**APPLICATION FOR SPECIAL USE PERMIT FOR USED AUTO
SALES**

APPLICATION #: **SUP26-0012**
APPLICANT: David Daoud
OWNER: Maayah Daoud
ADDRESS: 5057 Lewis Avenue
PARCEL(S): 09-81087
ZONING: CR-Regional Commercial
NEIGHBORHOOD: Mayfair Park
REPORT DATE: May 1, 2026
HEARING DATE: May 14, 2026
STAFF REVIEWER: Reising

Overall site plan.

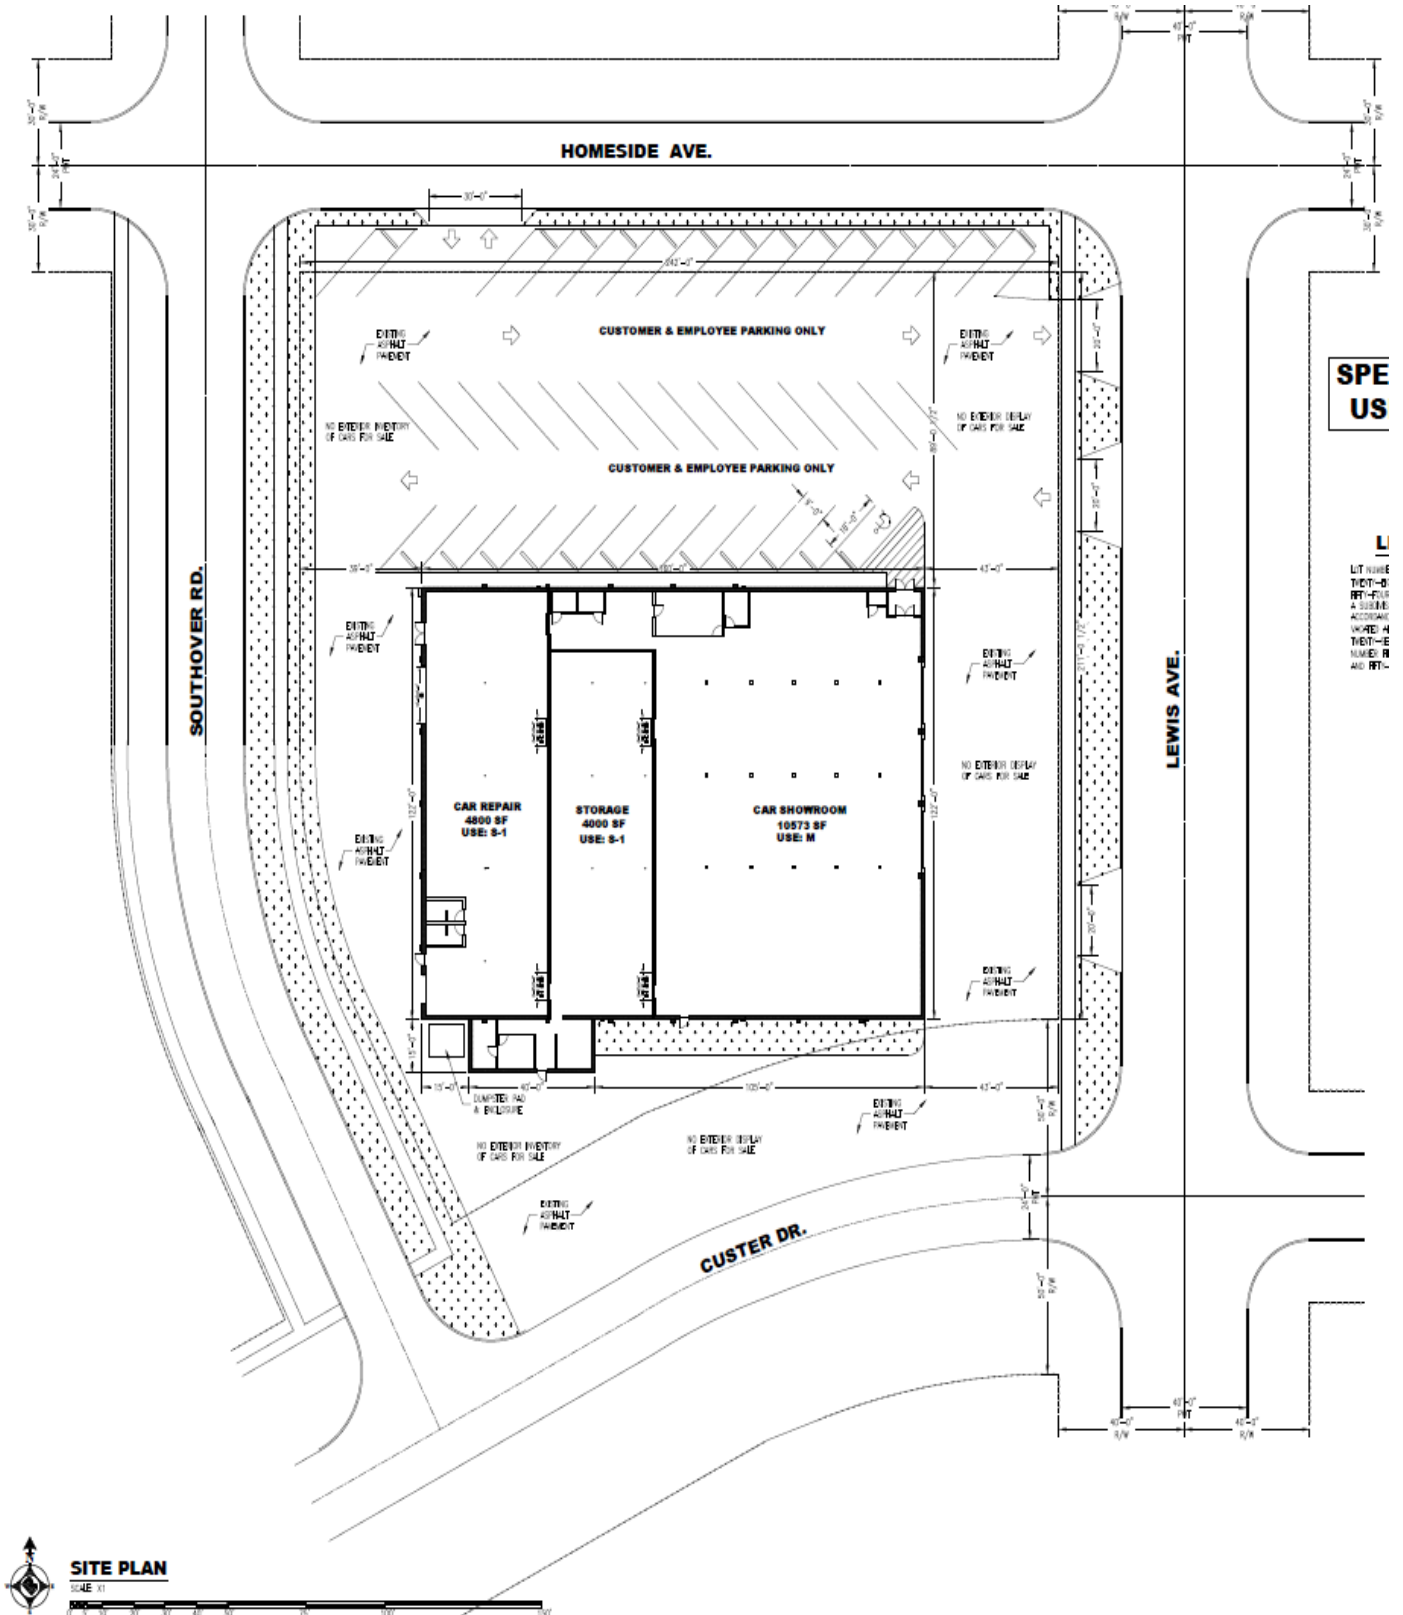
The maximum number of parking spaces permitted is twenty-four (24) based on the submitted site plan. A revised site plan showing the row of parking spaces along Southover Road eliminated and landscaping added is required as a condition of approval.

Additionally, landscaping shall be provided along Homeside Avenue to screen the business from abutting residences and reduce the chance of any negative secondary effects.

14. Sidewalk is required along Homeside Avenue and on Custer Drive for pedestrian traffic per TMC 11087.1300 and City of Toledo Complete Streets Policy Ordinance 391-23.
15. A sidewalk/pedestrian parking lot crossing is required from Lewis Avenue sidewalk to the building per TMC 1107.1602.
16. A van accessible parking space with a minimum of an 8' wide loading aisle is required per TMC 1107.1701 & 1107.1702 (the van loading aisle is not the right size).
17. Accessible parking signage must be posted directly in front of the parking space at a height of no less than 60 inches and no more than 72 inches above pavement level TMC 1107.1704.

18. All angled parking spots, driveways and drive aisles are required to be clearly dimensioned per TMC 1107.1911.
19. All parking in right-of-way along Homeside Avenue is not permitted and must be removed from the right-of-way.
20. Close the drive on Lewis Avenue closest to Custer Drive and drive on Homeside Avenue across from the residential. The two driveways closest to Homeside Avenue on Lewis Avenue consolidate into one 25' drive approach for two-way traffic pattern. New grass and curb will need to be installed to match adjacent areas.
21. Traffic Management wants the drive opening on Custer Drive reduced down to a maximum of a 25' driveway with new grass installed between sidewalk and Custer Drive.

26. Vehicles for sale are not allowed to be displayed in any off-street parking areas as site plan depicts interior display only. **A Special Use Permit amendment is required for the outdoor display of vehicles for this location.**
27. Repairs and service of inoperable vehicles shall be conducted wholly within an enclosed structure.
28. Off-street parking spaces for customers/employees shall be clearly delineated from spots within the outdoor display area.

29. Per TMC§1107.0304, the maximum number of parking spaces allowed is twenty-four (24). **Not acceptable as depicted. A revised site plan shall be submitted depicting a maximum of twenty-four (24) parking spaces for customers and employees. Parking in the right-of-way along northern edge of property shall be removed.**

30. Per TMC§1107.1700, at least one (1) van accessible parking space shall be provided. **Not acceptable as depicted. Abutting drive aisle must be at least eight feet (8') in width to meet van accessible parking space standards. A revised site plan with an eight foot (8') abutting aisle shall be provided.**

31. Fifteen-foot (15') buffer of landscaped frontage greenbelt meeting the requirements of TMC§1108.0202 are required along Southover Drive and Homeside Avenue. Trees and evergreen shrubs shall be depicted on a separate landscape plan. **Not acceptable as depicted. A frontage greenbelt with evergreen shrubs is required along the north and west property lines. North property line along Homeside Avenue requires eight (8) trees. West property line along Southover Road requires nine (9) trees. Existing trees may be counted toward the requirement.**
